REVISED RESPONSE TO REQUEST FOR ADDITIONAL INFORMATION

APR1400 Design Certification Review - 52-046

RAI No.: 264-8243

SRP Section: 06.02.05 – Combustible Gas Control in Containment

Figure 1 Schematic Diagram for ECSBS Check Valve

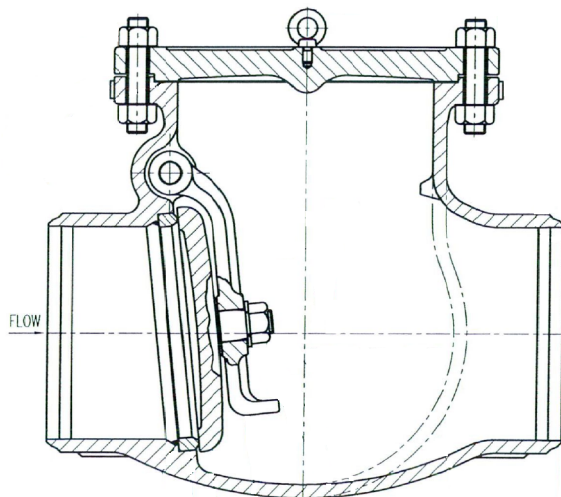
In the equipment survivability analysis described in DCD Tier 2, Section 19.2.3, credit is taken for maintaining the containment pressure below the factored load category of 123 psia, per DCD Tier 2, Section 19.2.4.2.3, by relying on the emergency containment spray backup system (ECSBS). See DCD Tier 2, Figure 19.1-3, Simplified Diagram – Containment Spray System. This is a single train system, with its own dedicated ECSBS spray ring header and an inside containment isolation check valve, V1014. This backup spray function is the basis provided for

limiting the equipment survivability analysis to 24 hrs, as stated in DCD Tier 2, Section 19.2.3.3.7.2, "Determination of Severe Accident Environmental Conditions." This valve should be shown to meet the equipment survivability conditions, including surviving a hydrogen burn and remaining open. This valve should be added to DCD Tier 2, Table 19.2.3-4.

The check valve has another function of water delivery to the ECSBS header during severe accidents. However, the ES evaluation of the check valve is the as same as piping its water delivery function to the ECSBS header, because of the following reasons:

- The check valve resists damage due to temperature increases because it consists of only metallic parts. The metallic parts resist thermal damage according due to the hydrogen burn or continuous temperature rise which results from decay heat.
- It is expected that the check valve continues to function due to its simple structure, as shown in Figure 1.

Therefore, it is not necessary to evaluate the survivability of check valve V1014, but the valve will be added to Table 19.2.3-4, as shown in Attachment 1 to this response. The discussion of the valve's resistance to thermal degradation will be relocated to a new section within 19.2.3.3.7.4 since the valve is not located outside containment which is the heading of the valve's current discussion.

Figure 19.1-3 Simplified Diagram - Containment Spray System

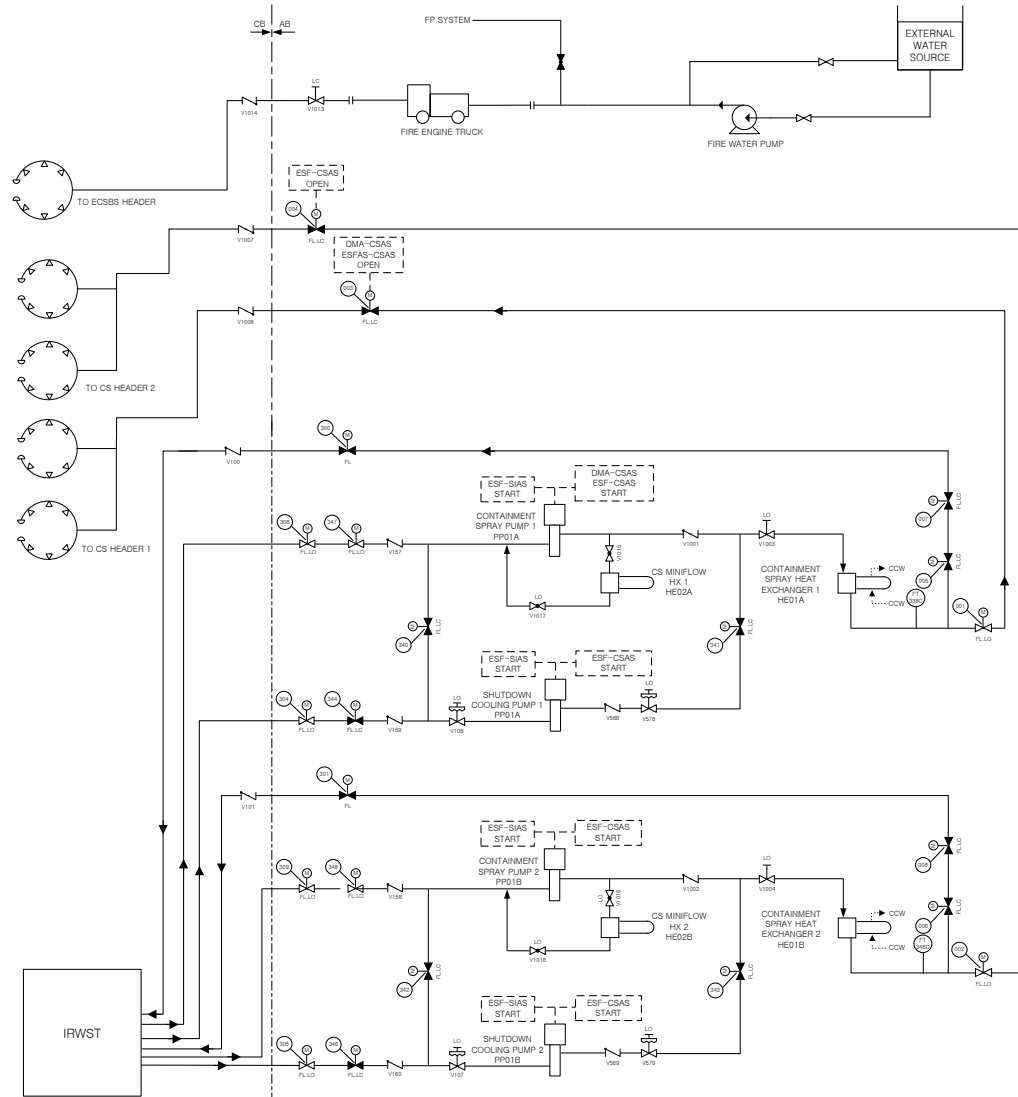
Please confirm that all of the check valves shown in DCD Figure 19.1-3, Simplified Diagram – Containment Spray System, are depicted correctly to indicate the direction of flow. Check valves V1014, V1008, and V1007 appear to be shown in an inconsistent direction as compared to V101 and V100. Adding flow direction arrows below the check valve symbol, as done in DCD Tier 2, Table 6.2.4-1, would provide clarification.

DCD Tier 2, Figure 19.1-3 will be revised to correct the directions of flow for check valves (V100, V101, V1007, V1008 and V1014), as shown in Attachment 2 to this response.
